175	02/23/11	CO #147
458	02/27/12	CO #337
458	03/16/12	ASI #190

ADDITIONAL NOTES FOR INSTALLATION OF METAL SUSPENSION CEILING SYSTEM PER OSHPD RESOLUTION TO COMPLY WITH CBC SECTION 1614A.1.1 AND 809.1.

A11.10.2

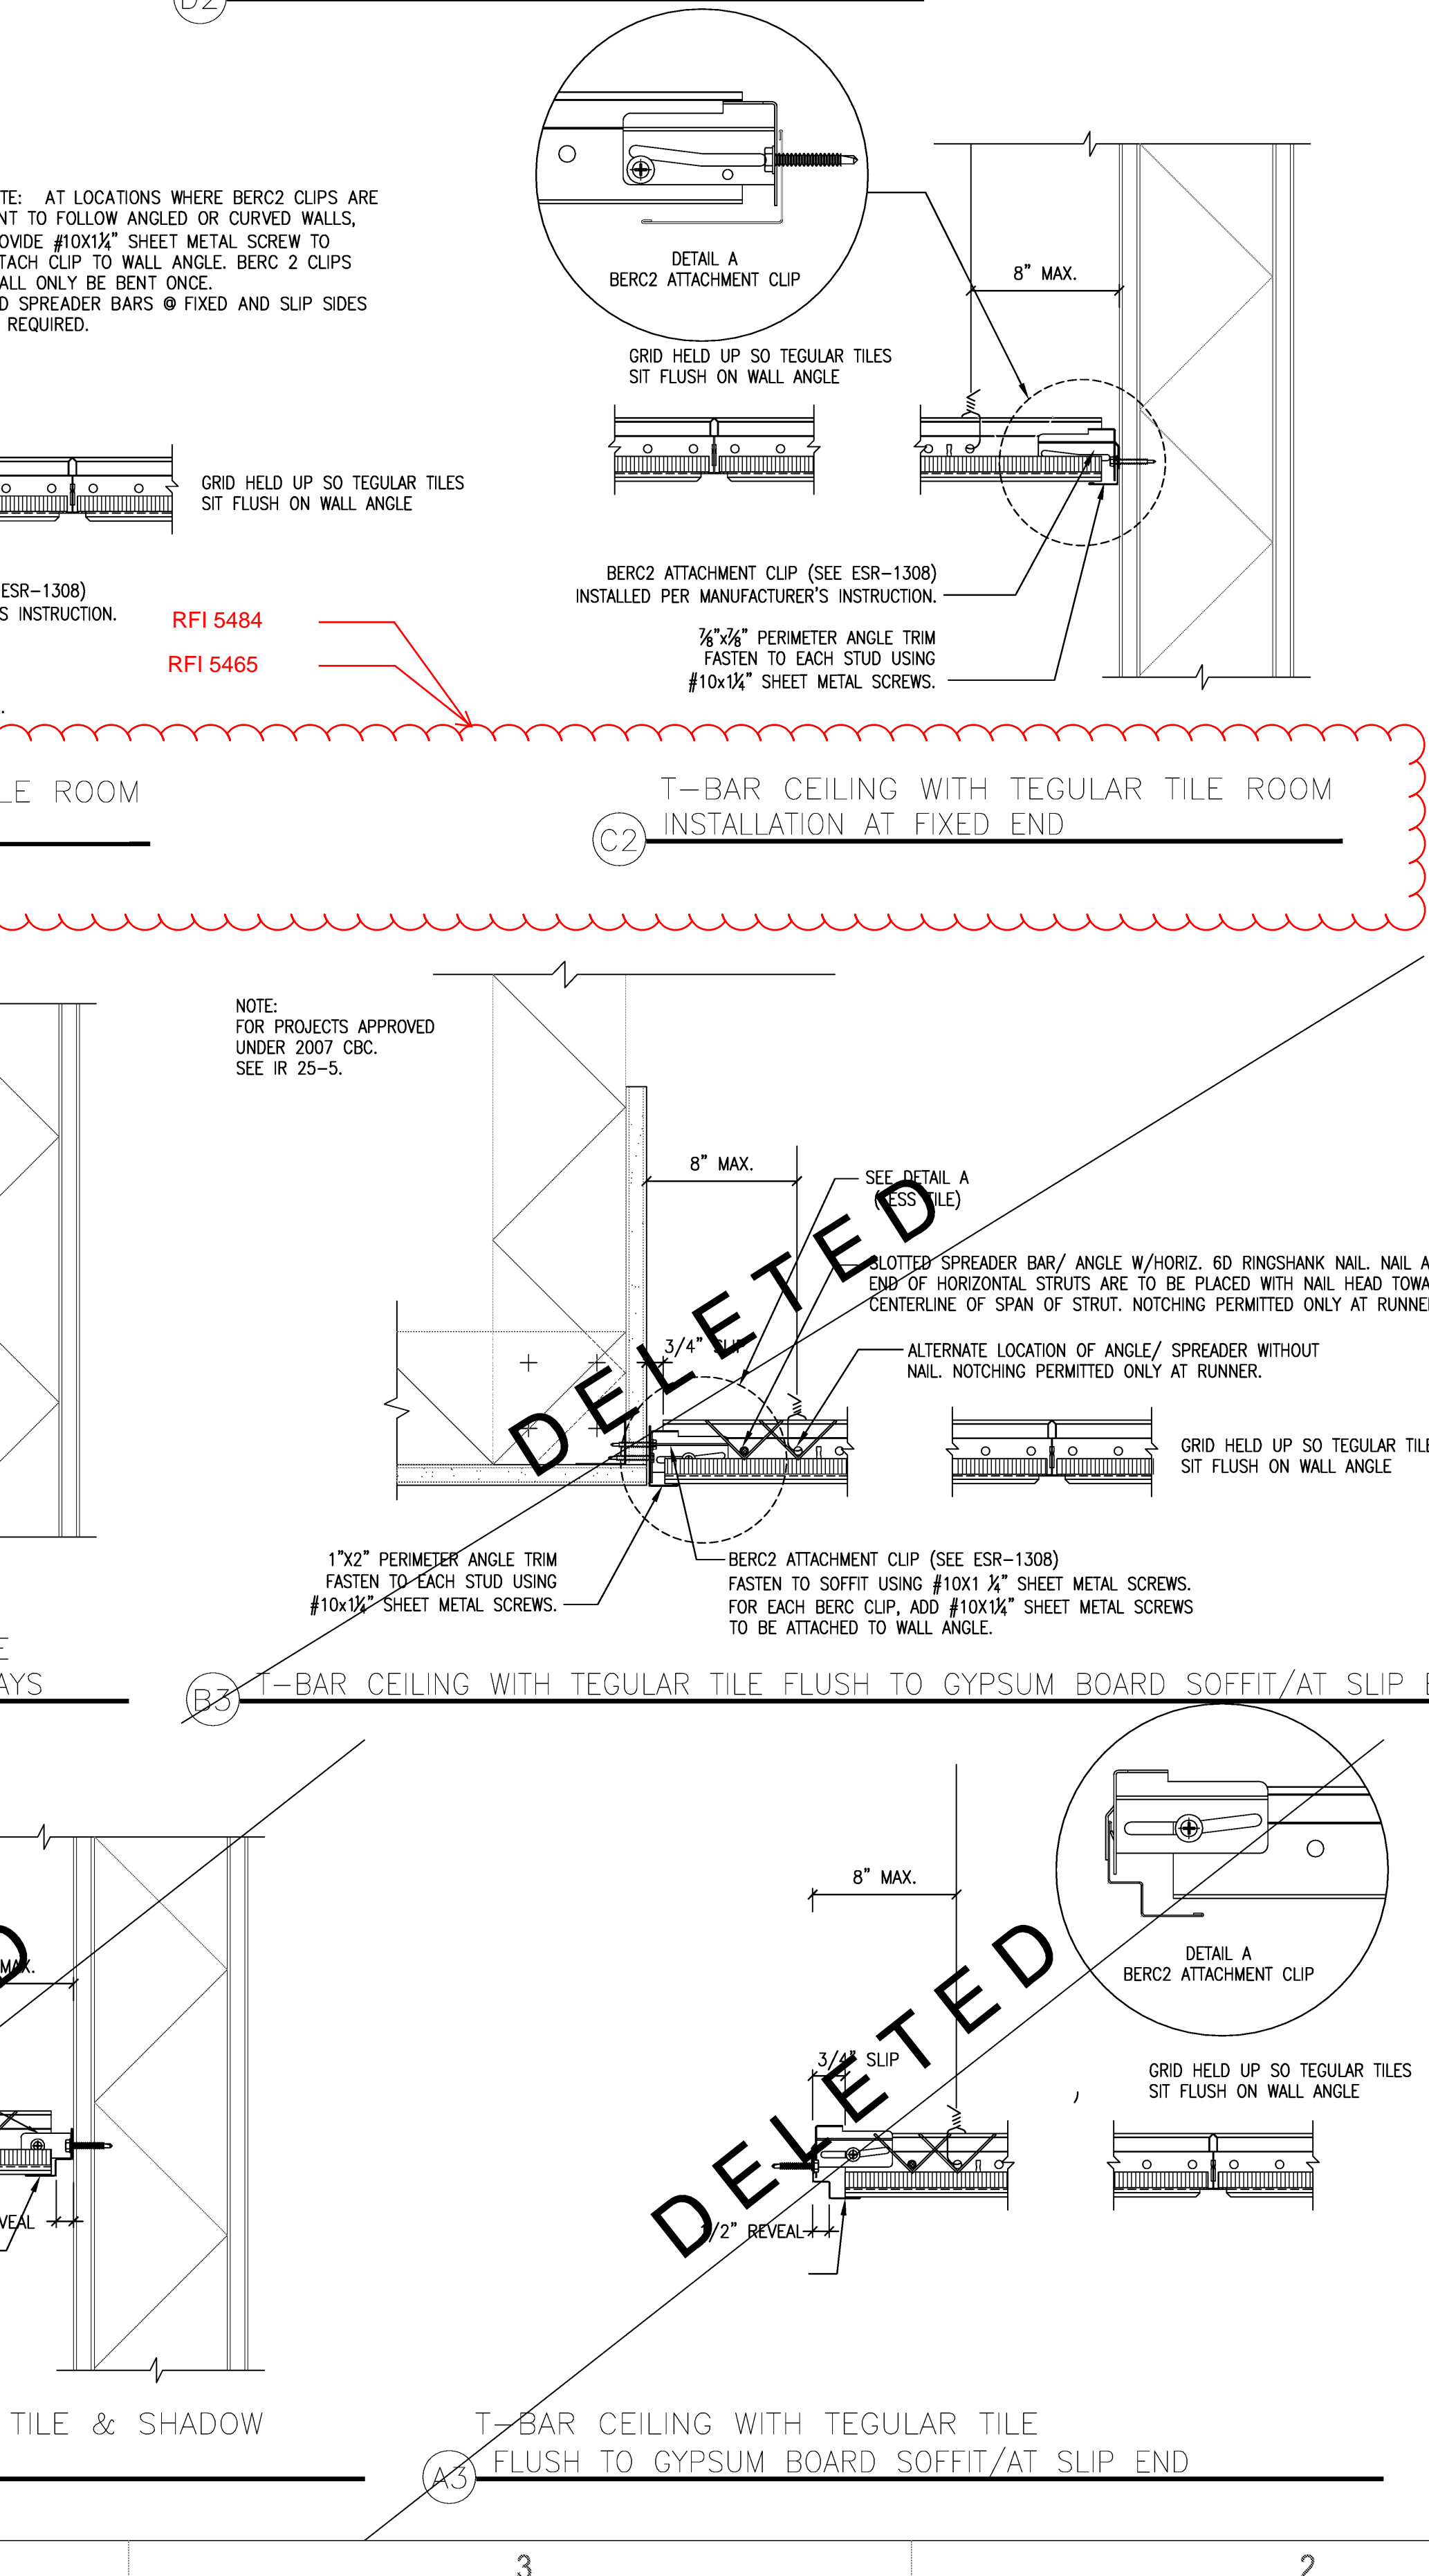
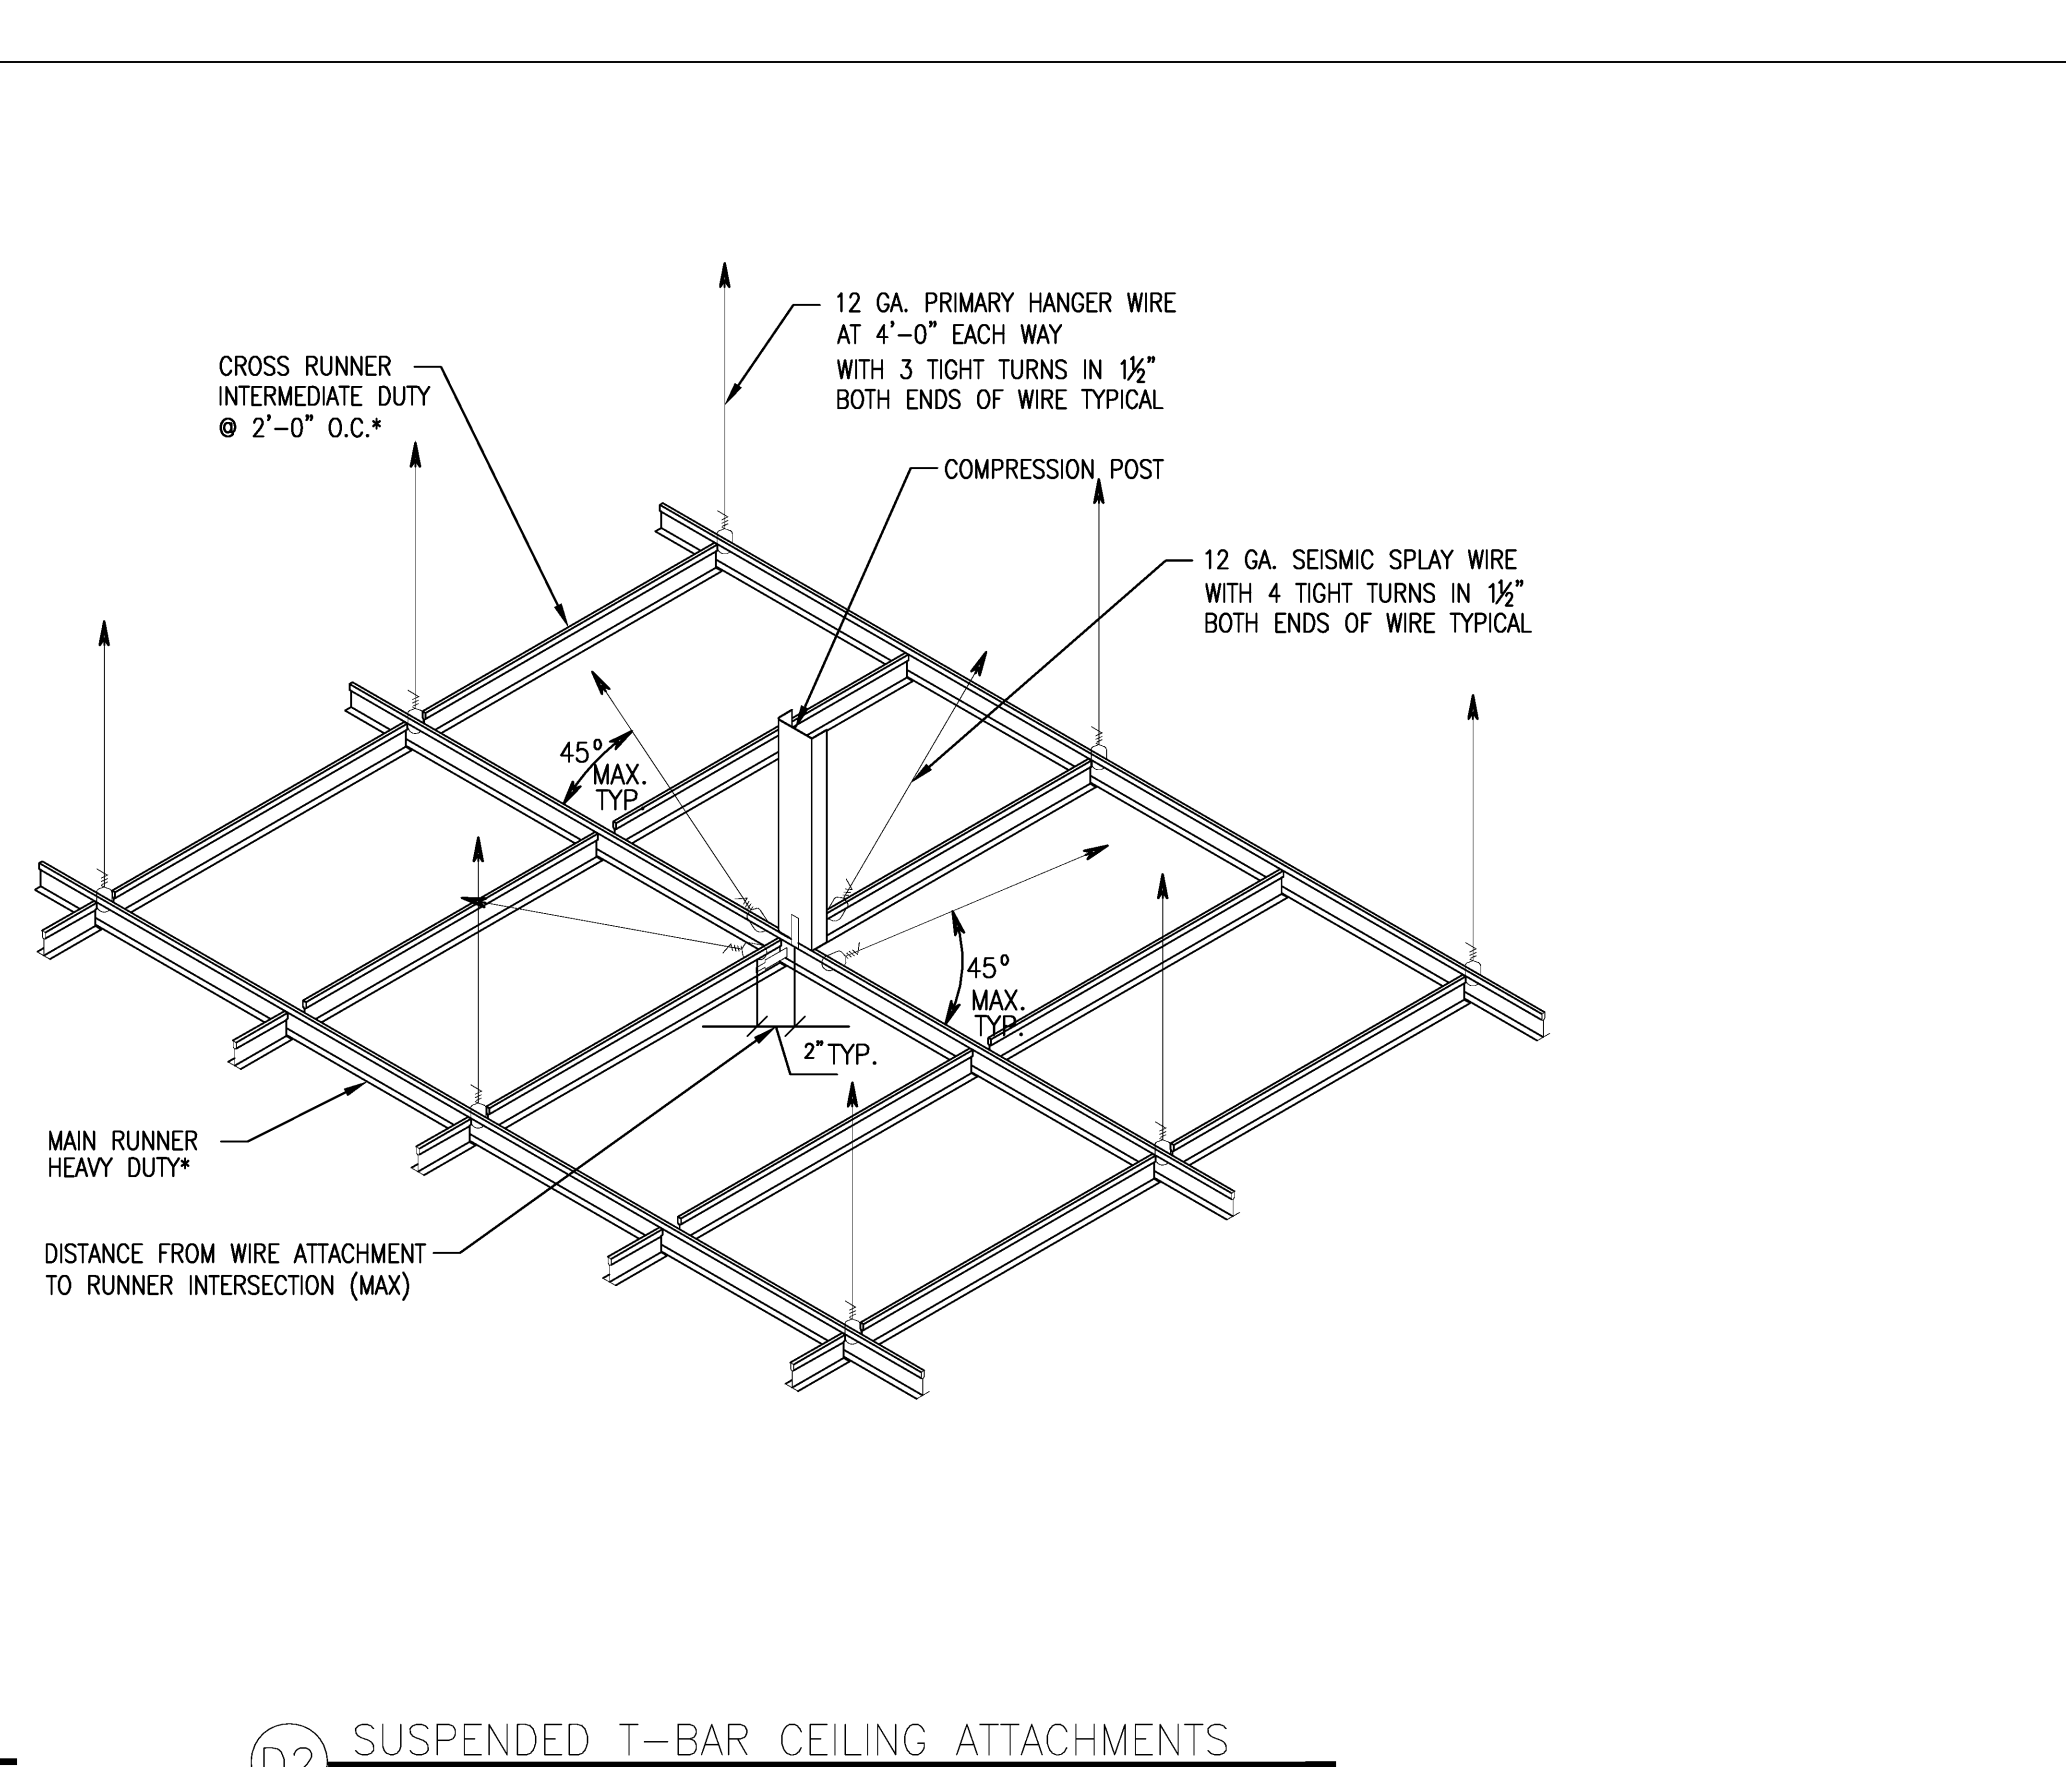
- WHERE CEILING GRID HAS NOT YET BEEN INSTALLED IN EXITWAYS:
 - USE DETAIL C4/A11.10.2
- FOR CEILING GRID IN EXITWAYS WHERE BERC CLIPS HAVE BEEN INSTALLED:
 - USE DETAIL B4 & B6/A11.10.2
 - VERTICAL HANGER WIRES WILL BE ADDED TO THE RUNNERS PERPENDICULAR TO THE WALL ANGLE FOR BOTH FIXED AND SLIP END AS REQUIRED ON A CASE-BY-CASE BASIS VERIFIED BY THE IOR, SEOR AND AOR.
